## **CHAPTER 5.0**

### **Comments on the Draft EIR**

**BRISBANE BAYLANDS SPECIFIC PLAN – DRAFT ENVIRONMENTAL IMPACT REPORT**

ENR 14-1  
**AIRPORT INFLUENCE AREA A -  
 REAL ESTATE DISCLOSURE AREA**  
 Comprehensive Airport Land Use Plan  
 For The Environs of San Francisco International Airport  
**C/CAG**  
 City/County Association of Governments  
 of San Mateo County, California

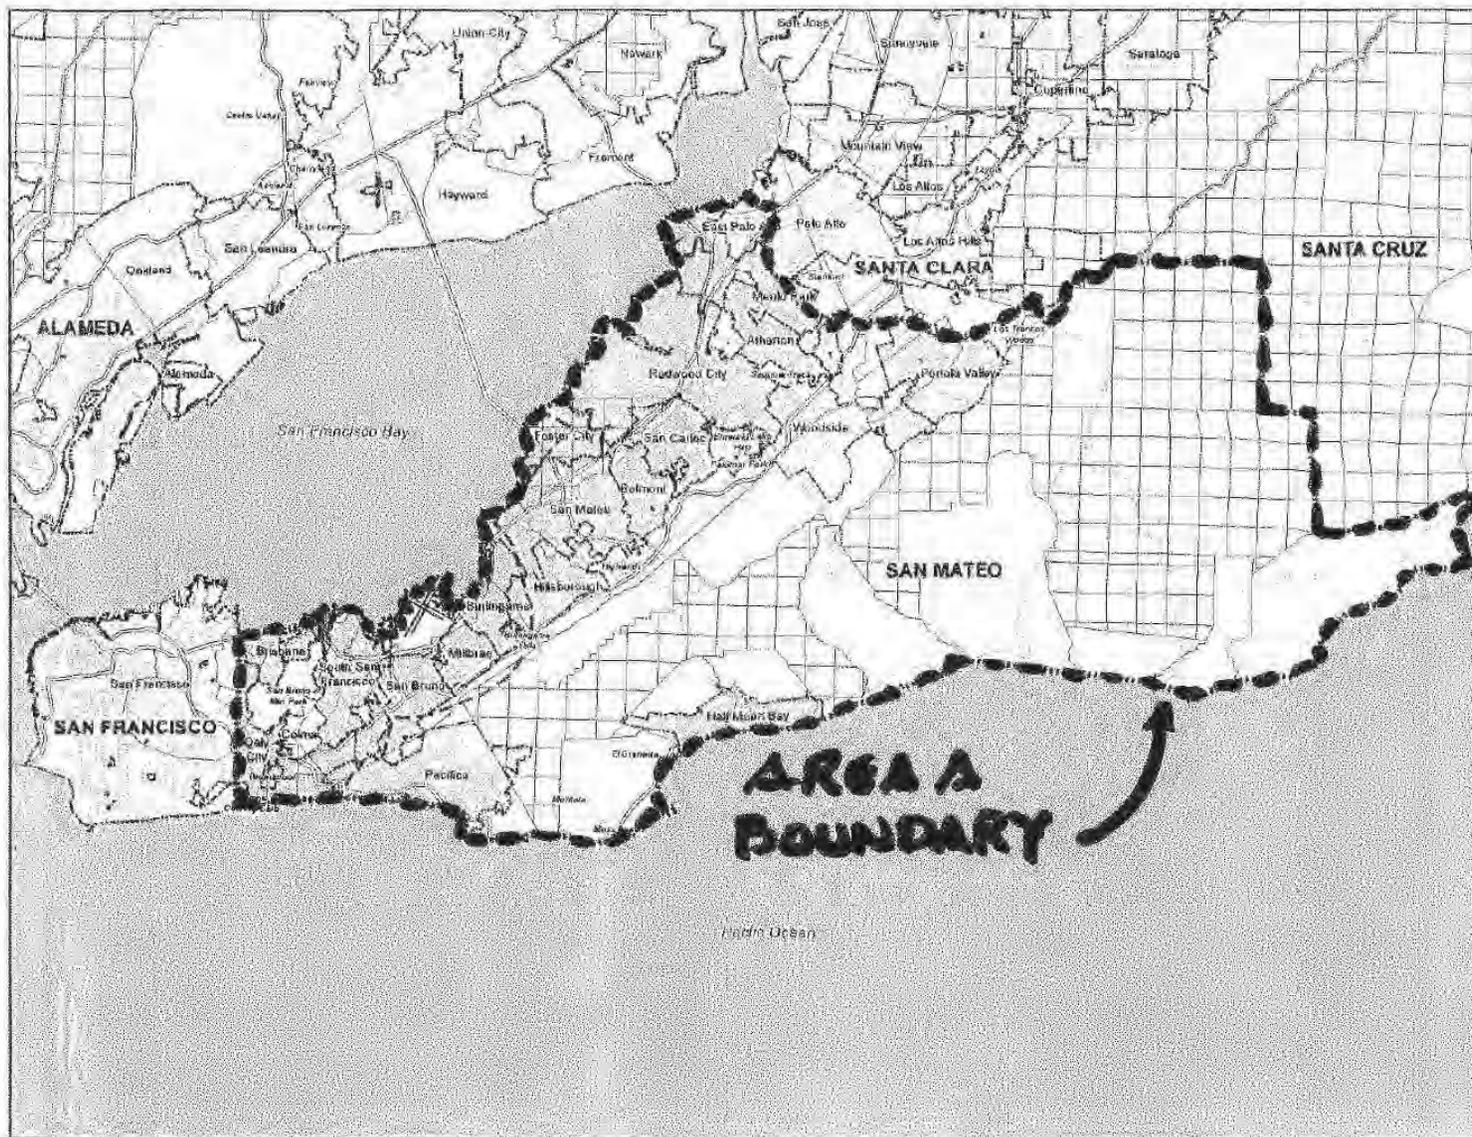
Within Area A, the real estate disclosure requirements of state law apply. Section 11010 (b)(f) of the Business and Professions Code requires people offering subdivided property for sale or lease to disclose the presence of all existing and planned airports within two miles of the property. The law requires that if the property is located within an “airport influence area” designated by the airport land use commission, the following statement must be included in the notice of intention to offer the property for sale:

Exhibit M-2  
**AIRPORT INFLUENCE AREA B -  
 LAND USE POLICY ACTION/PROJECT REFERRAL AREA**  
 Comprehensive Airport Land Use Plan  
 for the Environs of San Francisco International Airport  
**C/CAG**  
 City/County Association of Governments  
 of San Mateo County, California

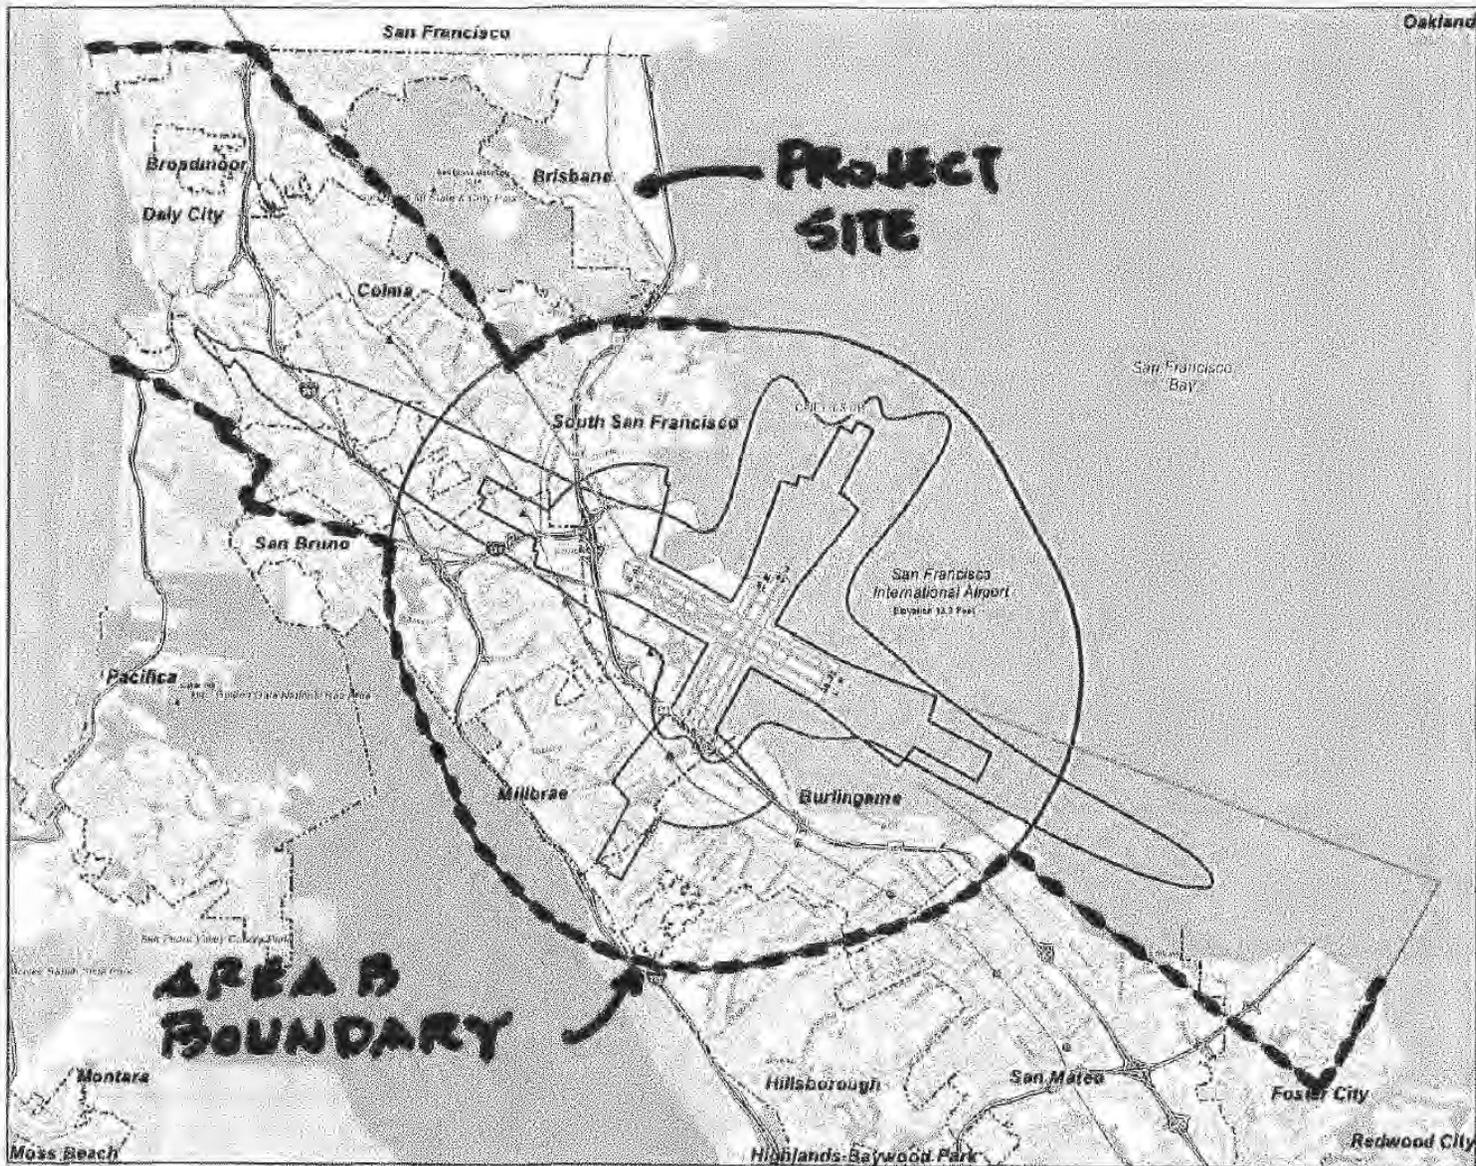
Within Area B, the Airport Land Use Commission (the CCAG Board) shall exercise its statutory duties to review proposed land use policy actions, including new general plans, specific plans zoning ordinances, plan amendments and rezonings, and land development proposals. The real estate disclosure requirements in Area A also apply in Area B. For purposes of this policy, parcels along the edge of the Area B boundary that are split by the boundary shall be considered as fully being within Area B.”

**San Benito Rd.**

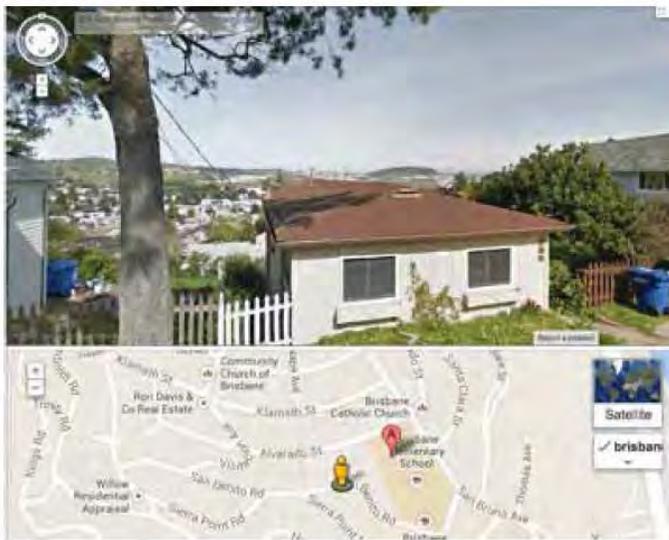
<b>DEIR</b> (Section; page #)	<b>Comments</b>	
<b>4. A-3 Viewpoint Locations</b>	These views emphasize optimal, high-end views and don't reflect what most residents will see from day-to-day. None reflect the appearance within the proposed site itself. Request additional views (see locations in appendix [e.g., Bayshore nr. Main Southbound; Bayshore nr Main Northbound; End of Tulare, San Benito Rd., Lake St., Tunnel Ave. & Creek, Tunnel Ave. & Beatty, etc.)	36
<b>4. A-9 "San Francisco Bay Plan"</b>	The San Francisco Bay Conservation & Development Commission's "100-foot shoreline band" limit is mentioned. We are missing a map that makes clear what parts of the project site are within this 100-foot shoreline band. (There is a map – Figure 4.I-2 on page 4.1-7 indicates the "areas subject to BCDC Jurisdiction" but it does not appear to address the 100 foot limit as the area defined appears to be irregular in width.)	37
